ADDENDUM DATE: April 21, 2022

ADDENDUM NO. 2

HARRIET'S HOPE

Addendum No. 2 to the Drawings and Project Manual, dated April 4, 2022, Harriet's Hope as prepared by Moody Nolan, Inc., 300 Spruce St. Suite 300, Columbus, OH 43215.

GRADING & STORM SEWER PLAN

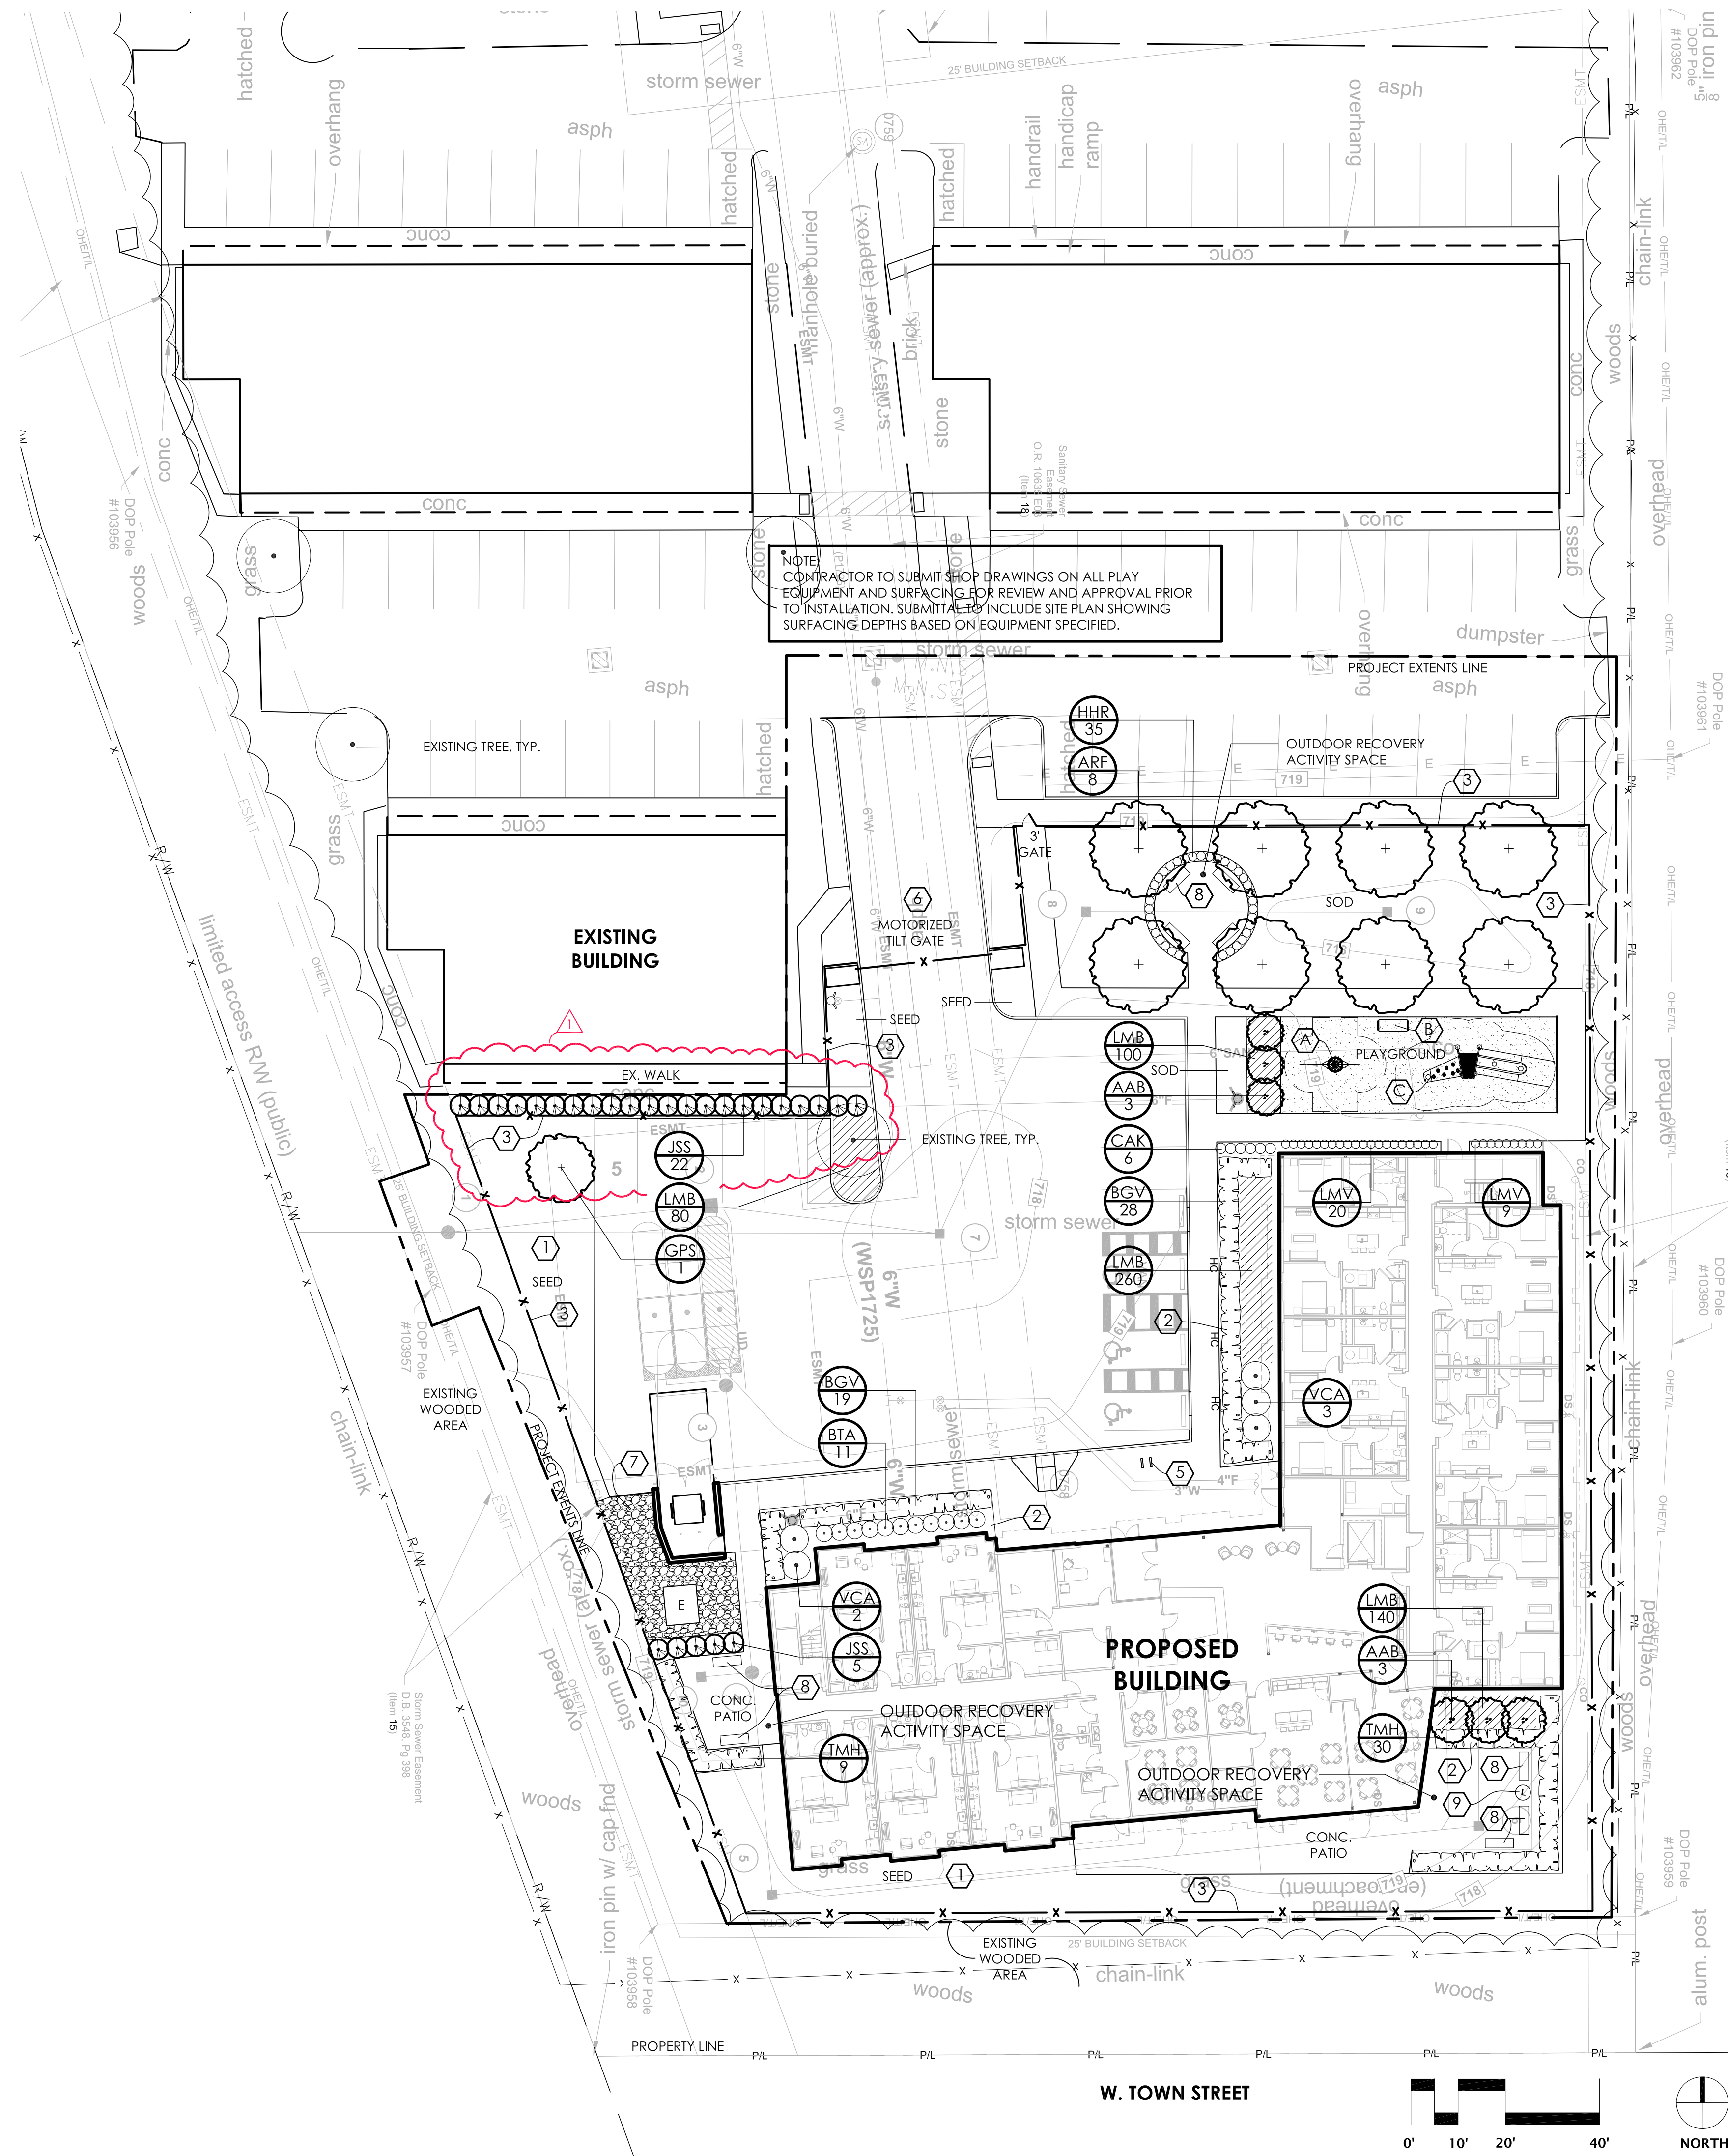
1. **REVISE** downspouts. One additional downspout added.

A101

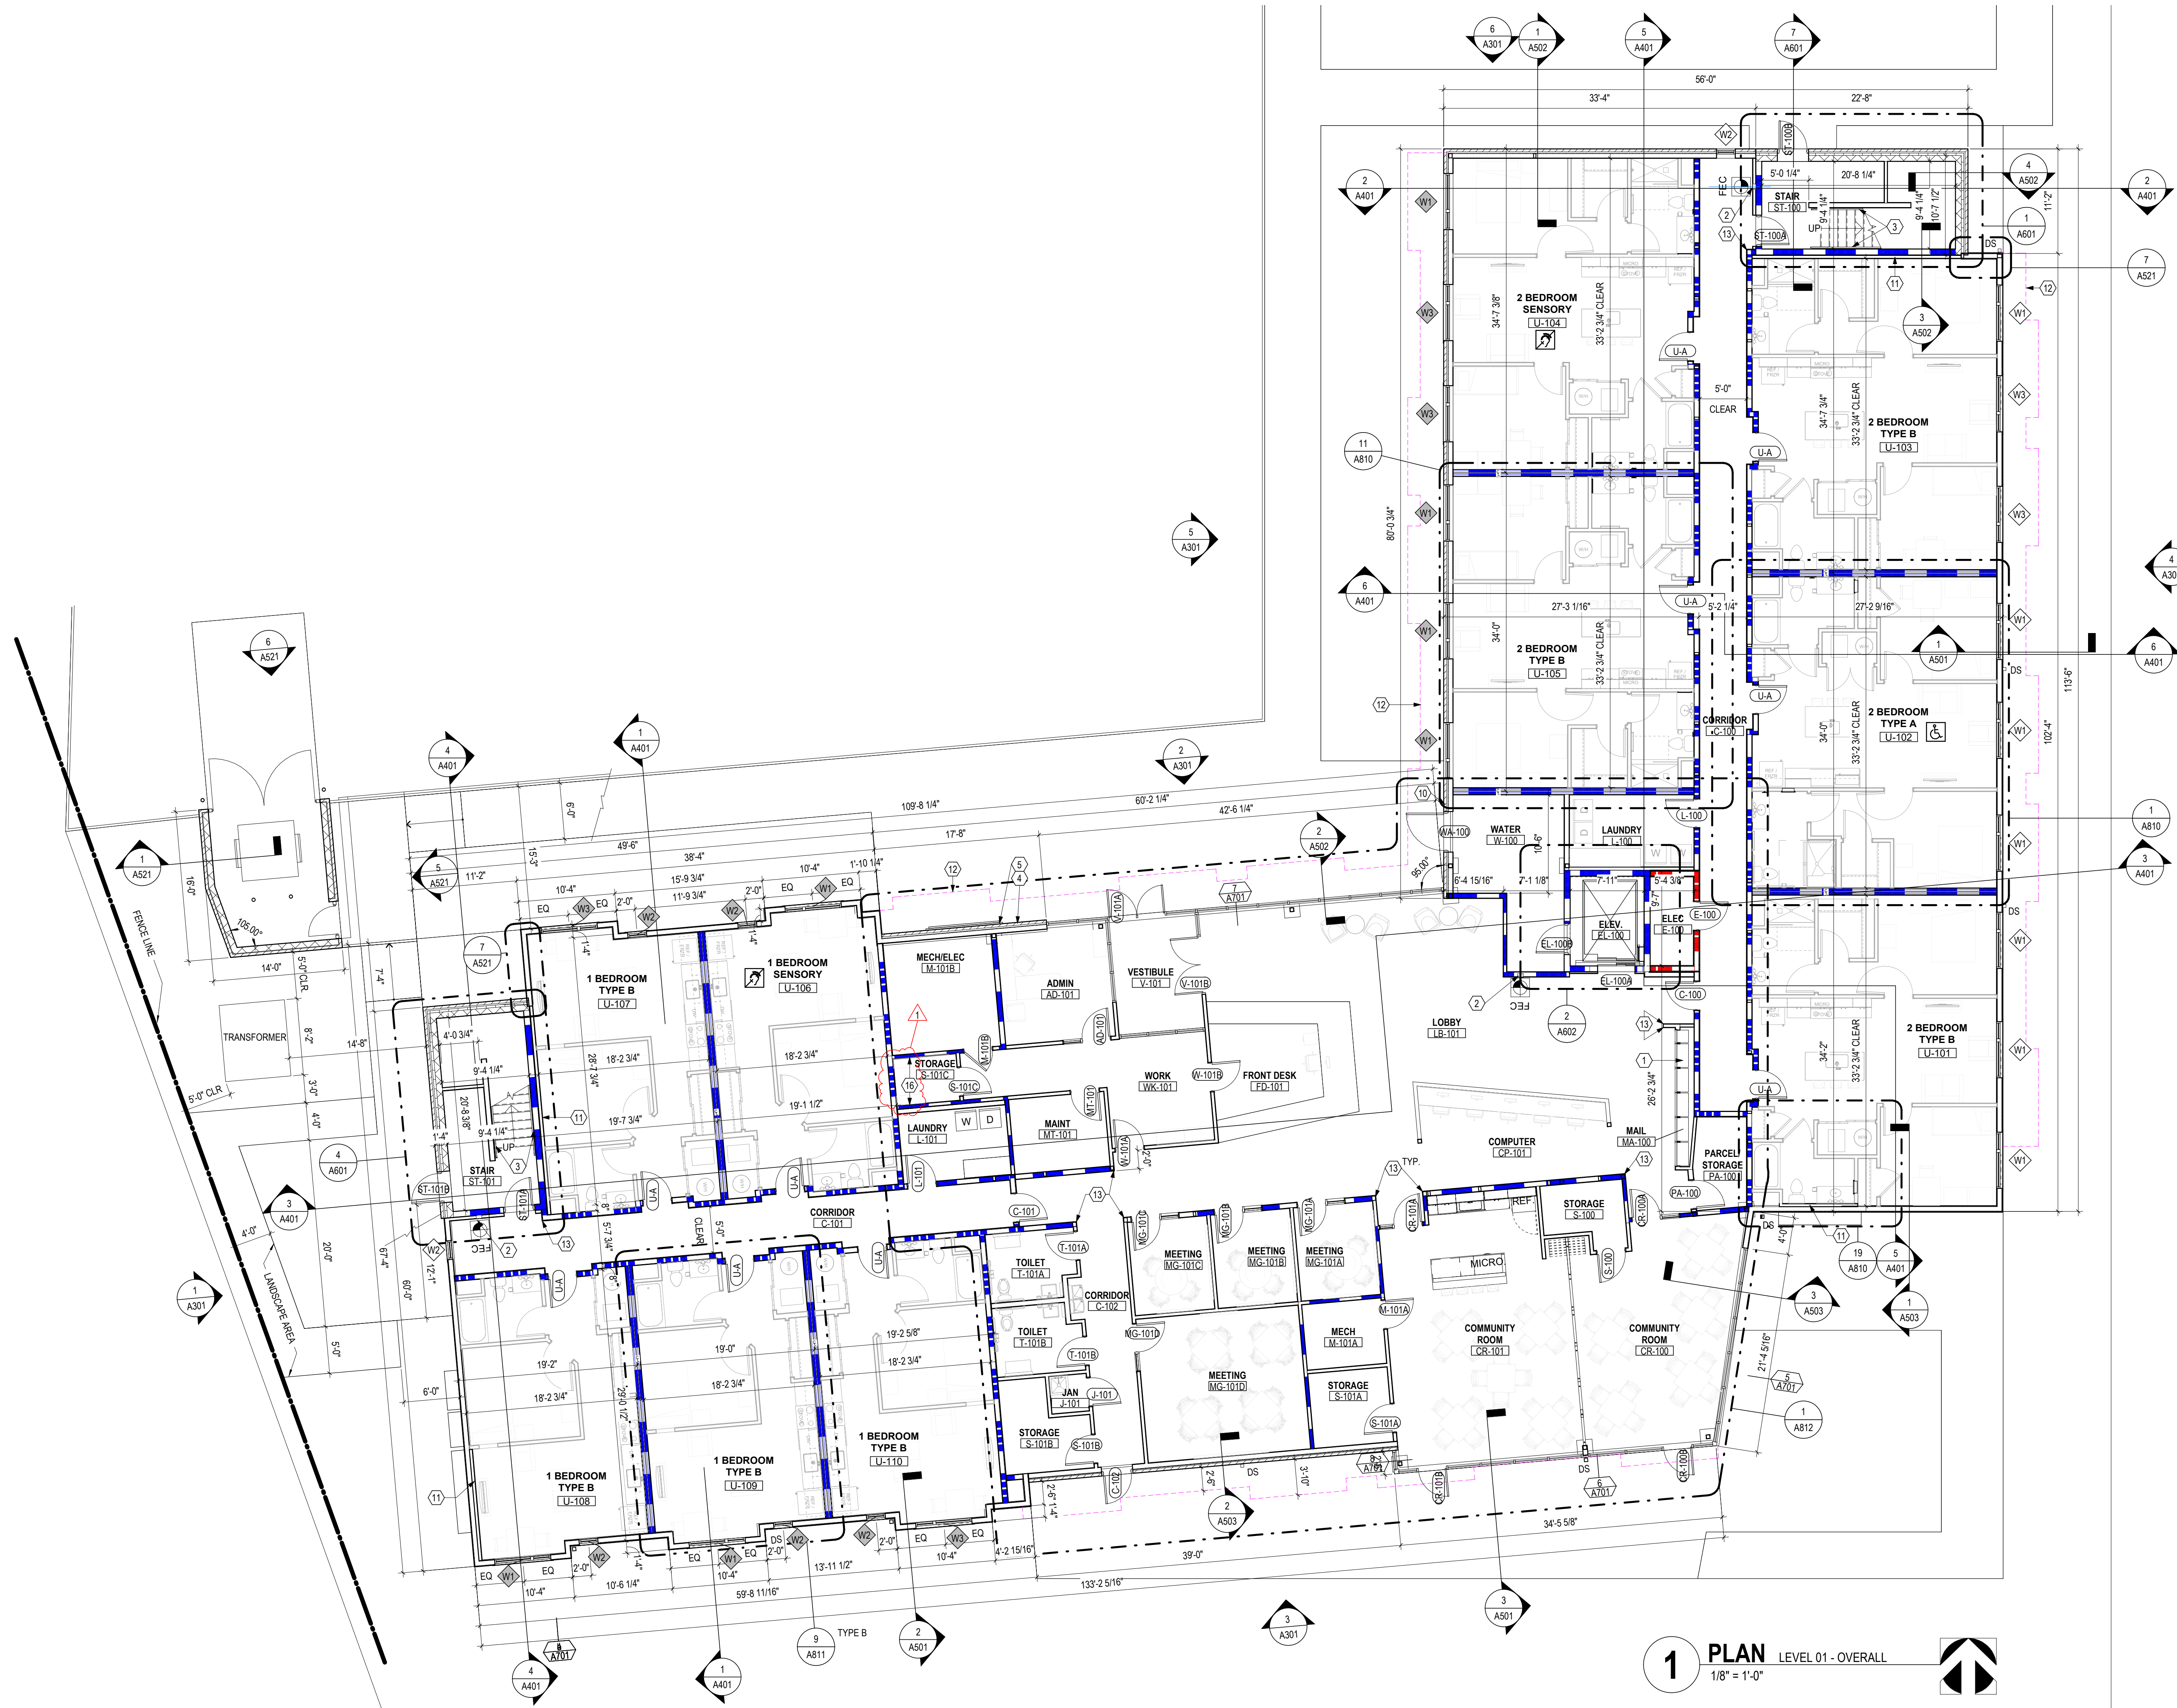
1. **ADD** 1/2" plywood sheathing under GWB in Storage S-101C.

1 PLAN ROOF
1/8" = 1'-0"

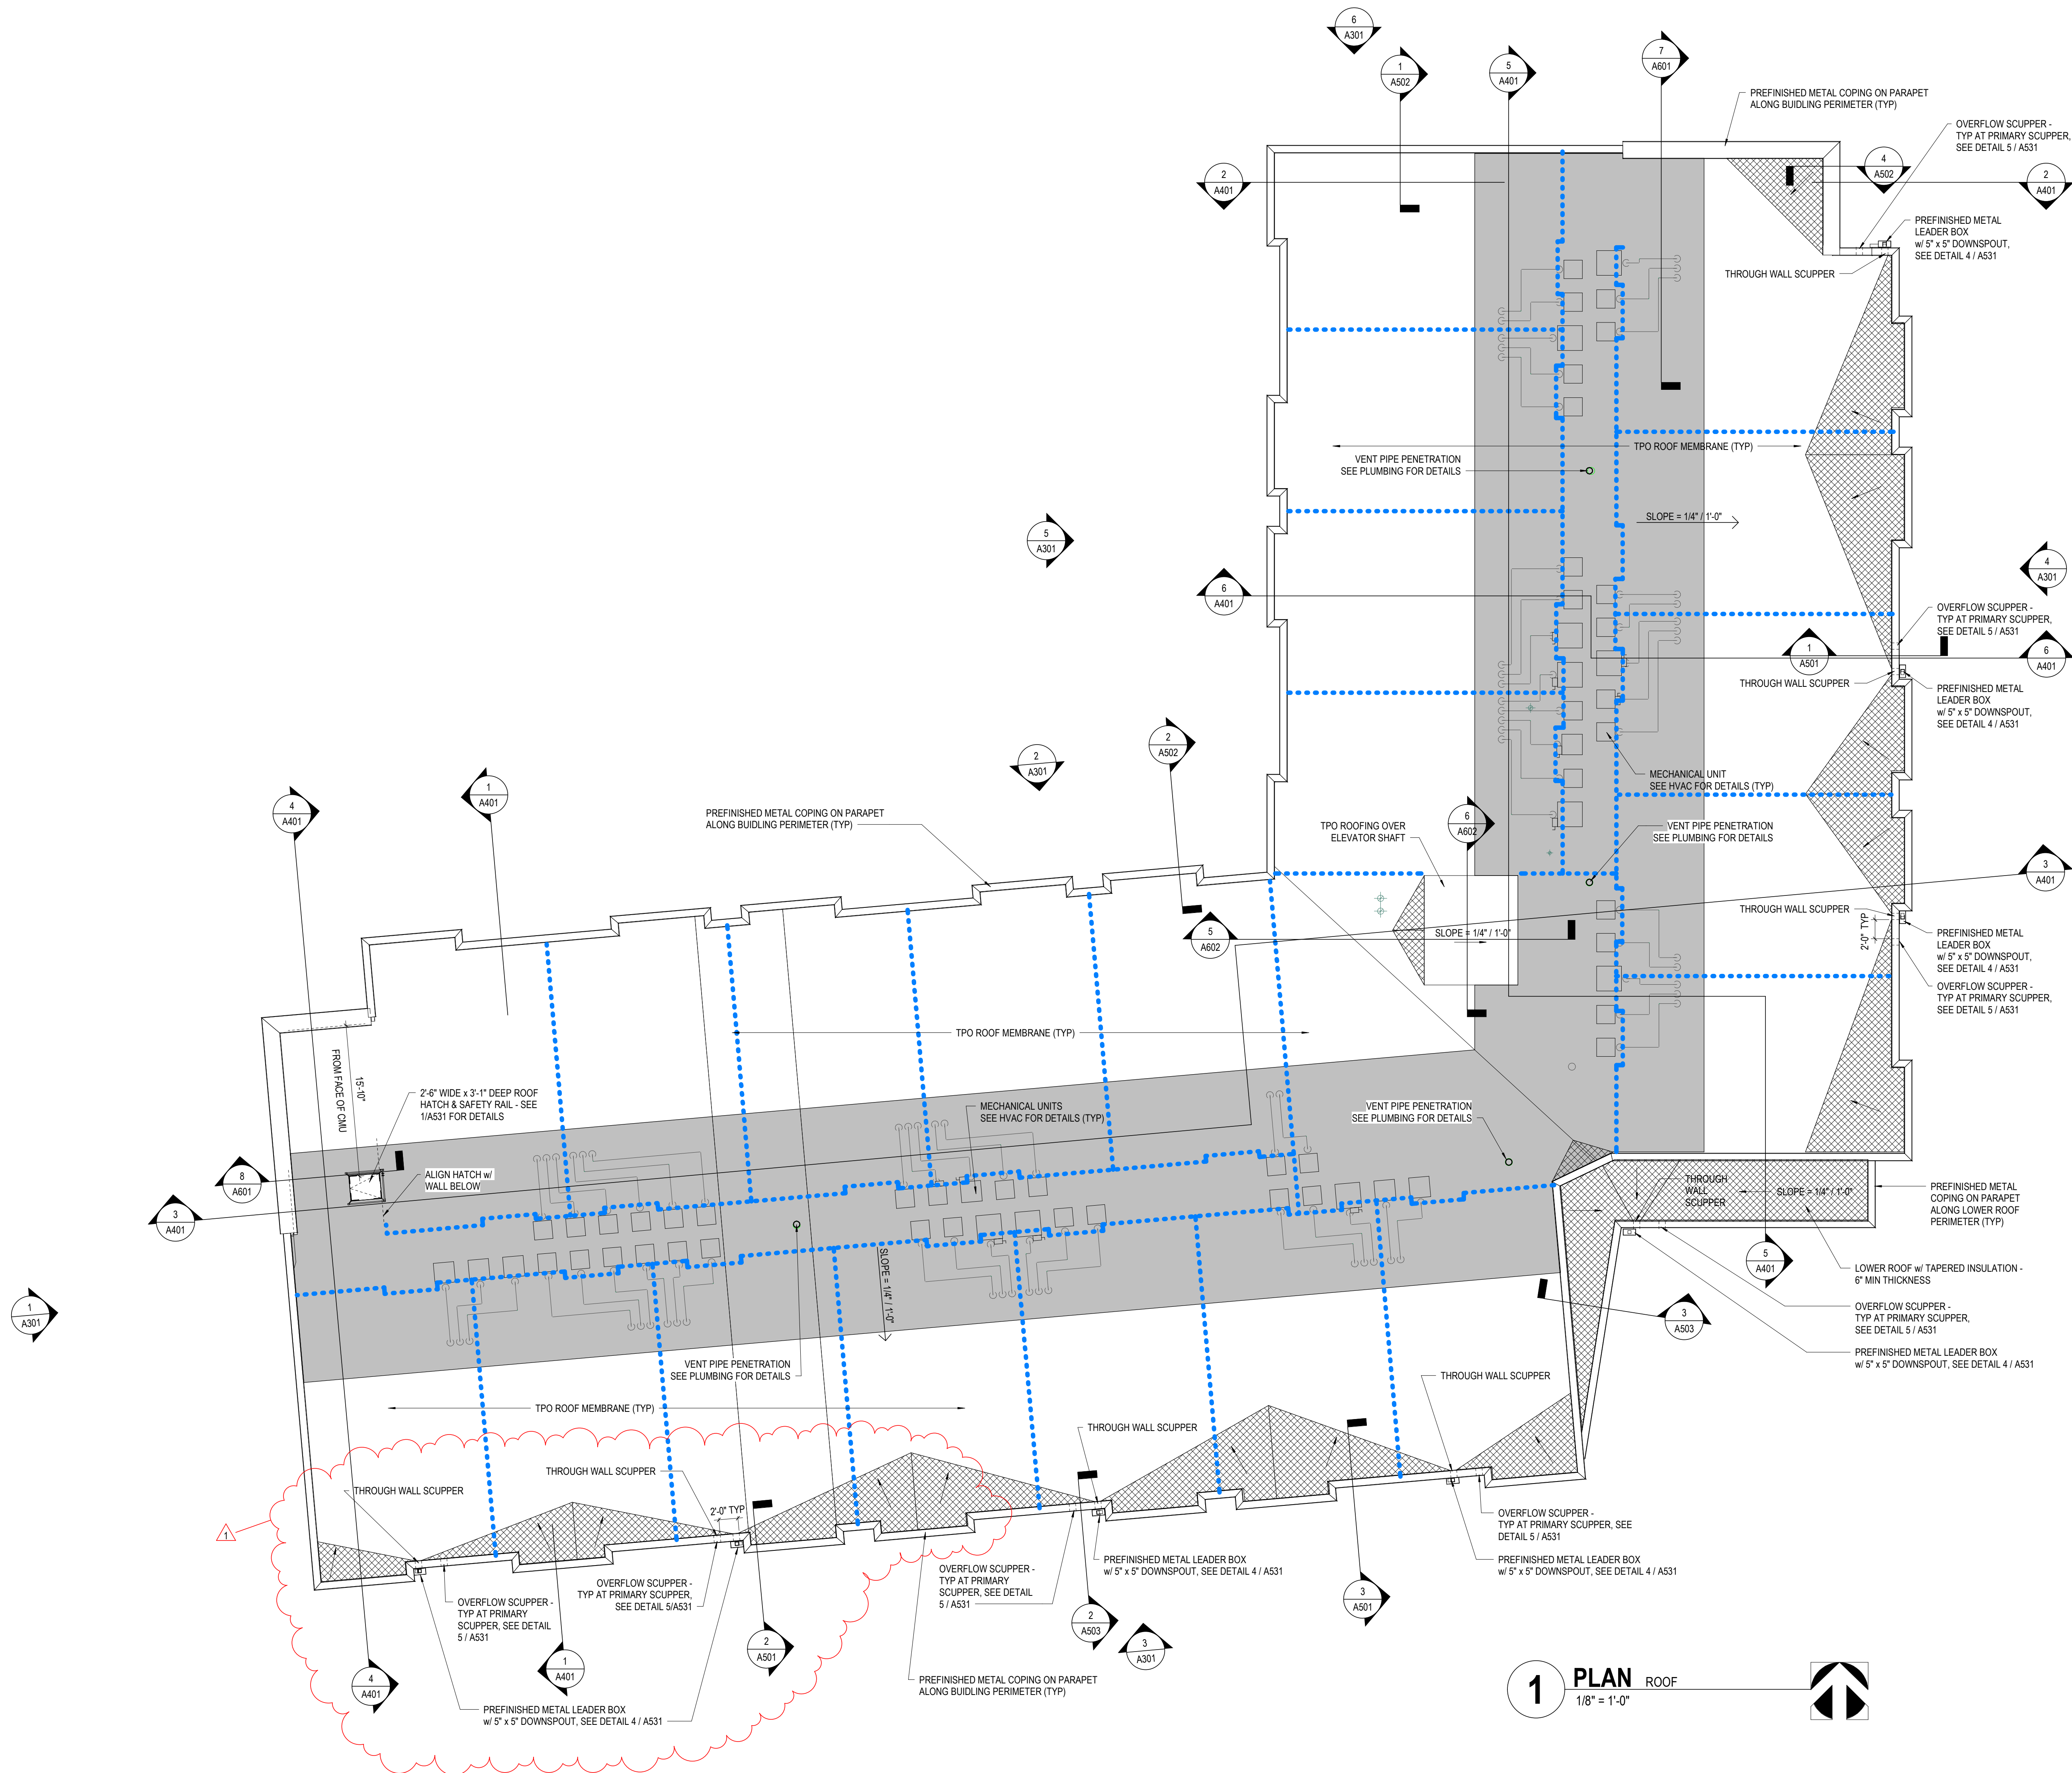
1. **ADD** downspout, scupper and overflow scupper to the southwest portion of the roof. Shift adjacent downspout, scupper and overflow scupper. Adjust tapered roof insulation. See attached revised roof plan for details.
